SERVICE BULLETIN**N° 139-601****DATE:** December 21, 2021**REV. :** A - May 11, 2022

TITLE**ATA 33 – INSPECTION AND REINFORCEMENT OF SEARCHLIGHT SUPPORT****REVISION LOG**

This Service Bulletin is issued in order to prescribe the inspection and, subsequently, the installation of searchlight support variant P/N 3G3340P01011.

Figure 1

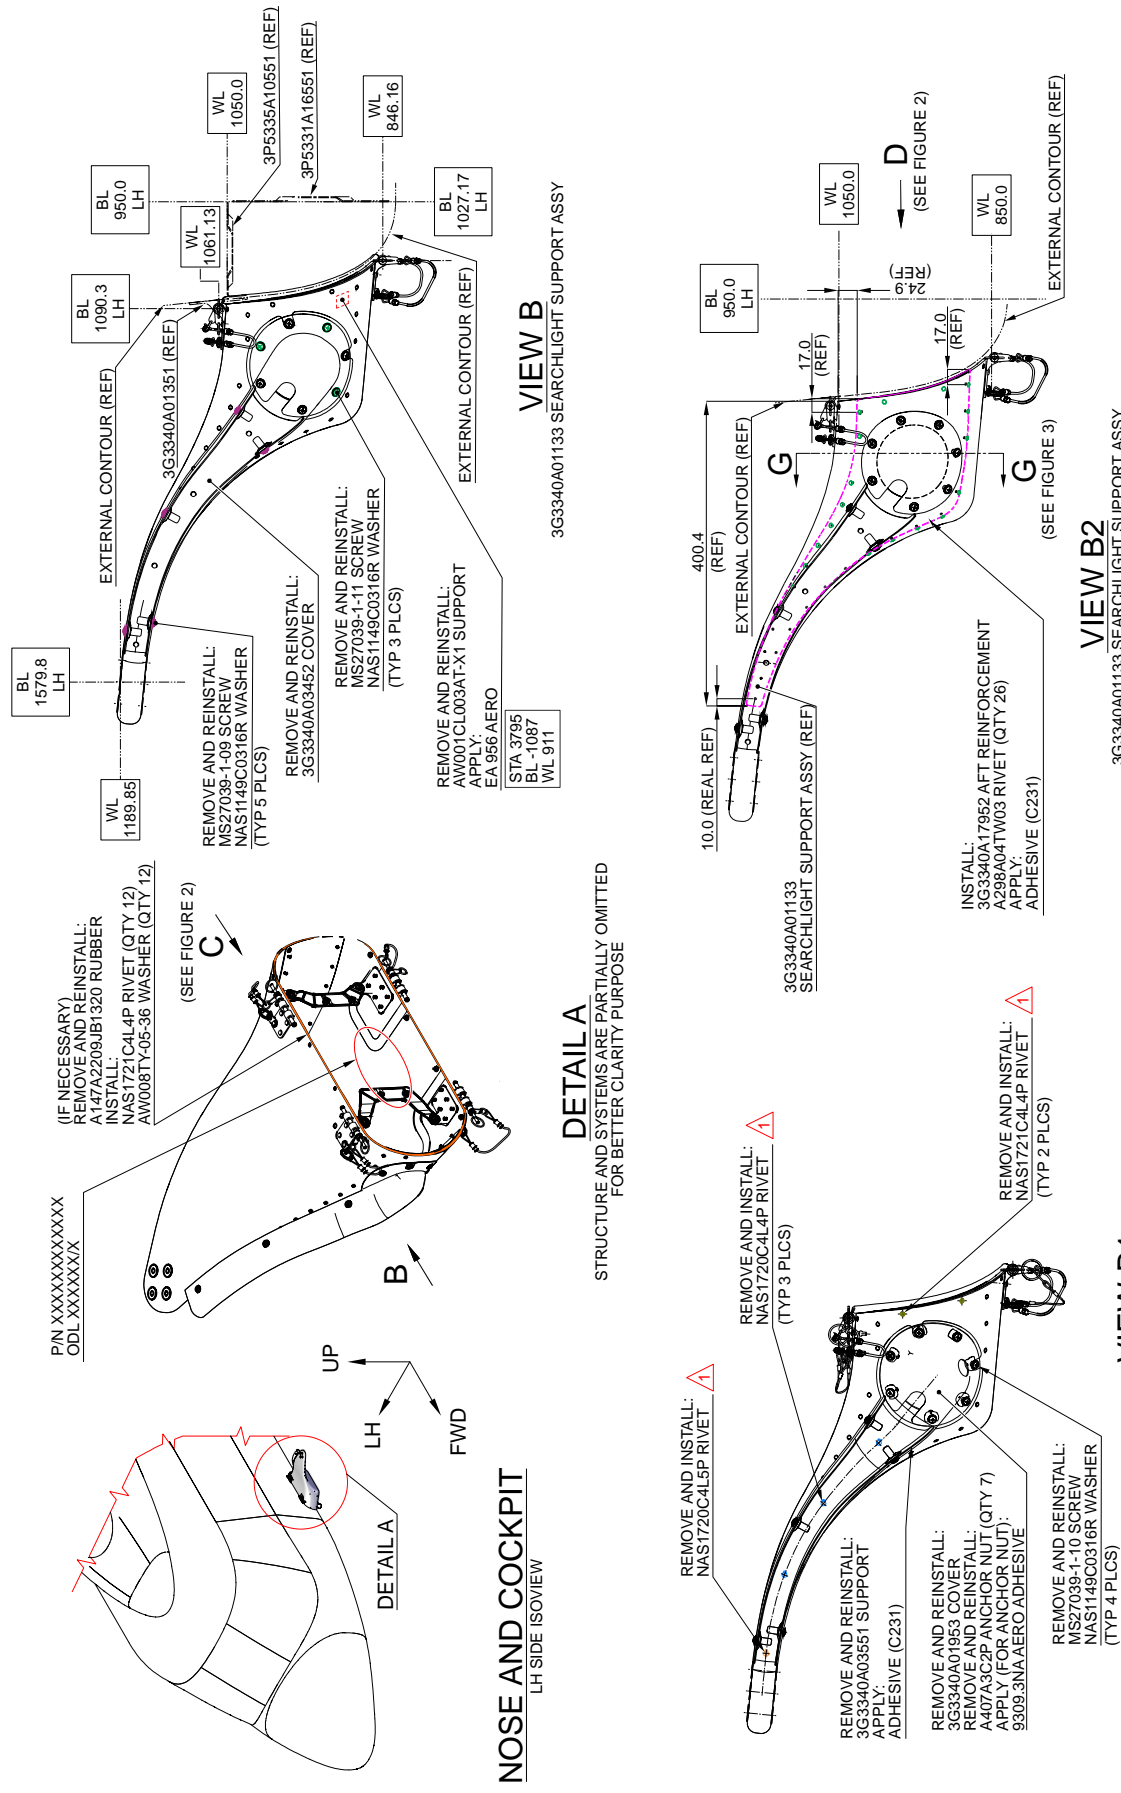
4. With reference to Figure 1 Detail A, check the “Ordine di Lavoro” marked inside the support searchlight assy.

4.1 With reference to Figure 1 View B, remove and retain for later reuse the cover P/N 3G3340A03452, n°5 screws P/N MS27039-1-09, n°3 screws P/N MS27039-1-11 and n°8 washers P/N NAS1149C0316R from the searchlight support assy.

4.2 With reference to Figure 1 View B1, remove and retain for later reuse the cover P/N 3G3340A01953, n°4 screws P/N MS27039-1-10 and n°4 washers P/N NAS1149C0316R from the searchlight support assy.

4.3 With reference to Figure 1 View B, remove and discard support P/N AW001CL003AT-X1 from the searchlight support assy.

4.4 With reference to Figure 1 View B1, remove n°7 anchor nut P/N A407A3C2P from the searchlight support assy.

4.5 With reference to Figure 1 Detail A, remove the rubber P/N A147A2209JB1320.

4.6 With reference to Figure 1 View B1, remove and retain for later reuse the support P/N 3G3340A03551 and remove and discard the rivet P/N NAS1720C4L5P, n°3 rivets P/N NAS1720C4L4P and n°2 rivets P/N NAS1721C4L4P from the searchlight support assy.

- 4.11 With reference to Figure 1 View B2 and in accordance with dimension shown, install the AFT reinforcement P/N 3G3340A17952 on the searchlight support assy by means of adhesive (C231).
- 4.12 With reference to Figure 1 View B2, fix the AFT reinforcement P/N 3G3340A17952 on the searchlight support assy by means of n°26 rivets P/N A298A04TW03.

- 4.19 With reference to Figure 1 View B1, fix the support P/N 3G3340A03551 on the searchlight support assy by means of the rivet P/N NAS1720C4L5P and n°3 rivets P/N NAS1720C4L4P.
- 4.20 With reference to Figure 1 View B1, install n°7 anchor nuts P/N A407A3C2P on the searchlight support assy by means of adhesive EA 9309.3NA AERO.
- 4.21 With reference to Figure 1 View B1, install the cover P/N 3G3340A01953 previously removed on the searchlight support assy by means of n°4 screws P/N MS27039-1-10 and n°4 washers P/N NAS1149C0316R previously removed.
- 4.22 With reference to Figure 1 View B, install support P/N AW001CL003AT-X1 on the searchlight support assy by means of adhesive EA 956 AERO.

- 4.23 With reference to Figure 1 Detail A, install rubber P/N A147A2209JB1320 on the searchlight support assy by means of adhesive EC1357, n°12 washers P/N AW008TY-05-36, n°12 rivets P/N NAS1721C4L4P.

- 4.24 With reference to Figure 1 View B, install the cover P/N 3G3340A03452 previously removed on the searchlight support assy by means of n°5 screws P/N MS27039-1-09, n°3 screws P/N MS27039-1-11 and n°8 washers P/N NAS1149C0316R previously removed.
 - 4.25 With reference to Figure 1 Detail A, remark the reworked searchlight support assy as P/N 3G3340P01131 by means of an indelible pen.
5. If necessary, in accordance with AMP DM 39-L-33-49-04-00A-720A-K, install the power conditioning interface unit on the searchlight support assy.

Figure 2

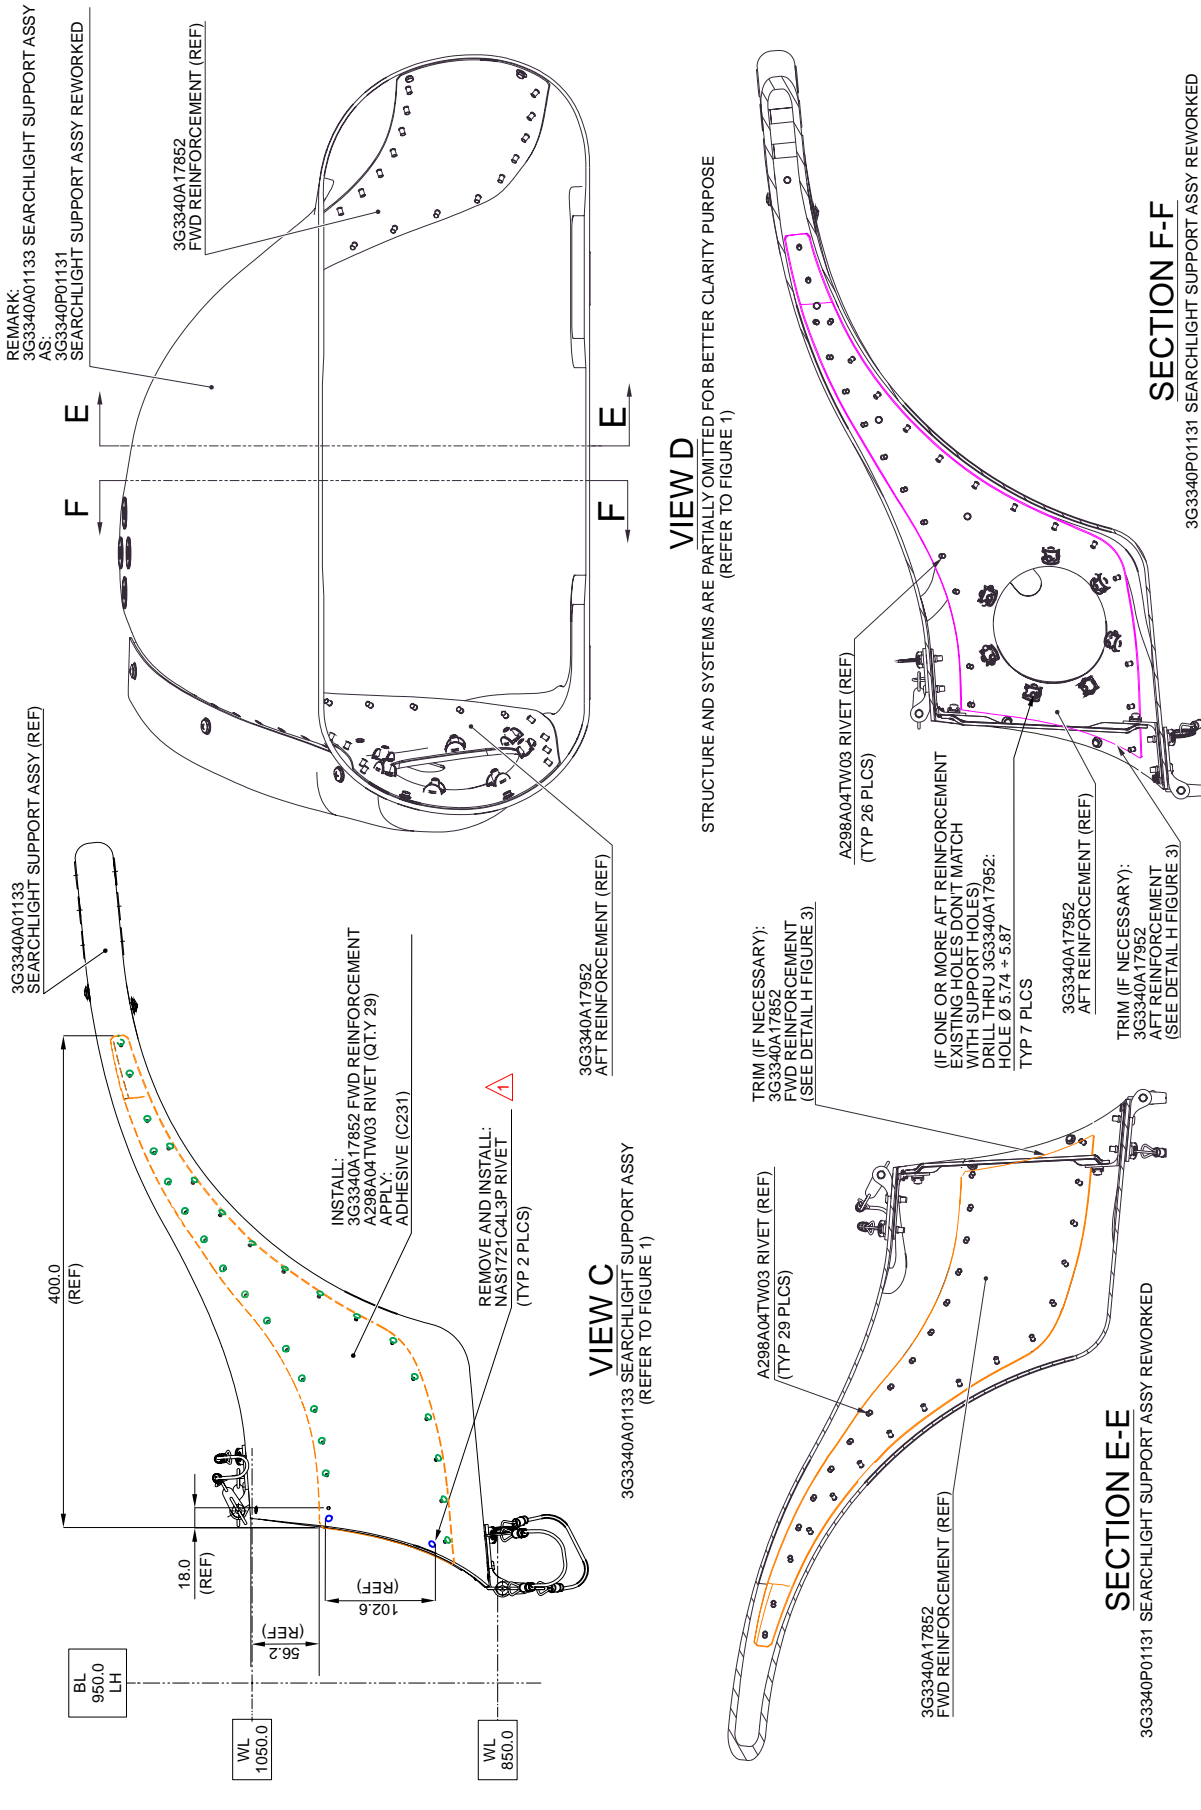
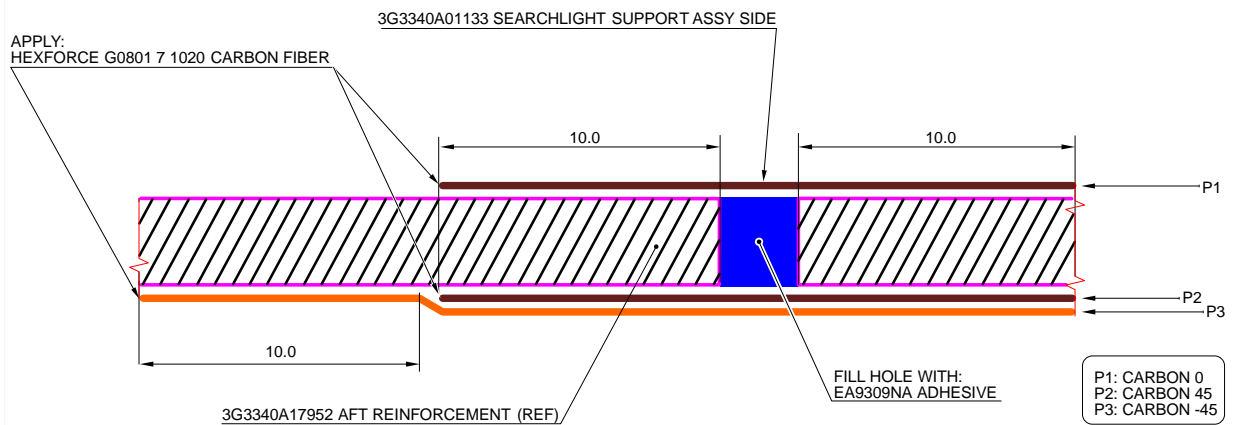
4.7 With reference to Figure 2 Section F-F, temporarily locate the AFT reinforcement P/N 3G3340A17952 in its position inside the searchlight support assy.

- 4.10 With reference to figure 2 Section F-F, countermark 26 rivet holes on the searchlight support assy.

- 4.13 With reference to Figure 2 Section E-E, temporarily locate the FWD reinforcement P/N 3G3340A17852 in its position inside the searchlight support assy.
- 4.14 With reference to Figure 3 Detail H, trim the FWD reinforcement on the gasket side as indicated.

- 4.15 With reference to figure 2 Section E-E, countermark 29 rivet holes on the searchlight support assy.
- 4.16 With reference to Figure 2 View C and in accordance with dimension shown, install the FWD reinforcement P/N 3G3340A17852 on the searchlight support assy by means of adhesive (C231).
- 4.17 With reference to Figure 2 View C, fix the FWD reinforcement P/N 3G3340A17852 on the searchlight support assy by means of n°29 rivets P/N A298A04TW03.
- 4.18 With reference to Figure 1 View B1, place and install the support P/N 3G3340A03551 previously removed on the searchlight support assy by means of adhesive (C231).

⚠ IT IS ALLOWED TO USE OVER SIZE OF RIVET IN CASE OF OVALIZED HOLES

Figure 3

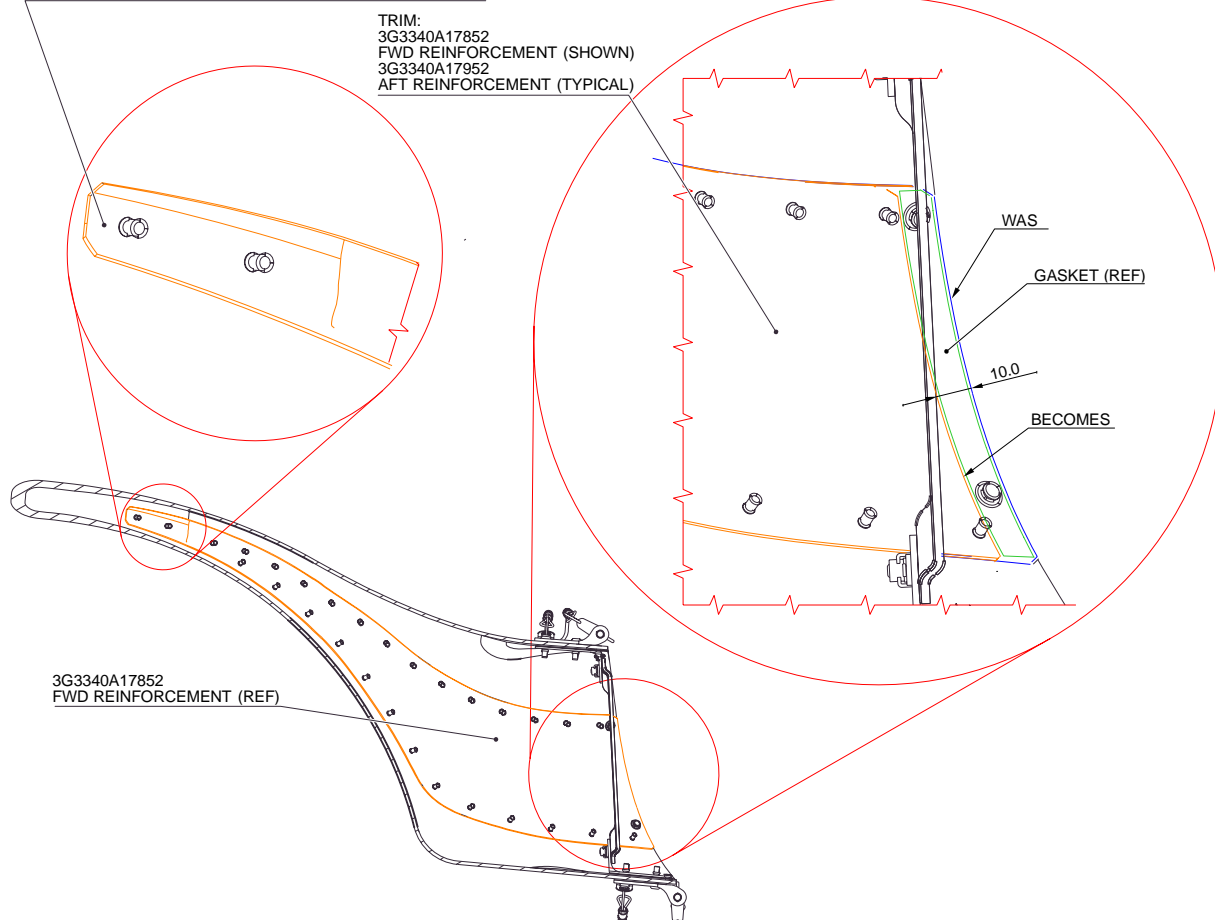
If necessary, it is possible to trim the AFT reinforcement to let it fit with the internal part of the support. Make sure to maintain the minimum edge margin of the rivet holes.
(Refer to Figure 3 Detail H).

4.8 With reference to Figure 3 Detail H, trim the AFT reinforcement on the gasket side

- 4.9.1 With reference to Figure 3 Section G-G, apply a layer (P1) of Carbon fiber dry fabric HexForce G0801 7 1020 and let it cure.
- 4.9.2 With reference to Figure 3 Section G-G, fill 7 screw holes with EA9309NA.
- 4.9.3 With reference to Figure 3 Section G-G, apply a layer (P2 and P3) of Carbon fiber dry fabric HexForce G0801 7 1020 and let them cure.
- 4.9.4 In accordance with CSRP-A-51-21-02-00A-028A-D, protect repaired area with primer.
- 4.9.5 With reference to Figure 2 Section F-F, countermark and drill n°7 anchor nuts holes $\varnothing 5.74 \div 5.86$ thru the aft reinforcement.

If necessary, it is possible to trim the FWD reinforcement to let it fit with the internal part of the support. Make sure to maintain the minimum edge margin of the rivet holes (Refer to Figure 3 Detail H).

IF NECESSARY IT IS POSSIBLE TO SLIGHTLY TRIM THE
FWD REINFORCEMENT TO LET IT FIT WITH THE INTERNAL
PART OF THE SUPPORT. MAKE SURE NOT TO LOSE THE
MINIMUM EDGE MARGIN OF THE RIVET HOLES
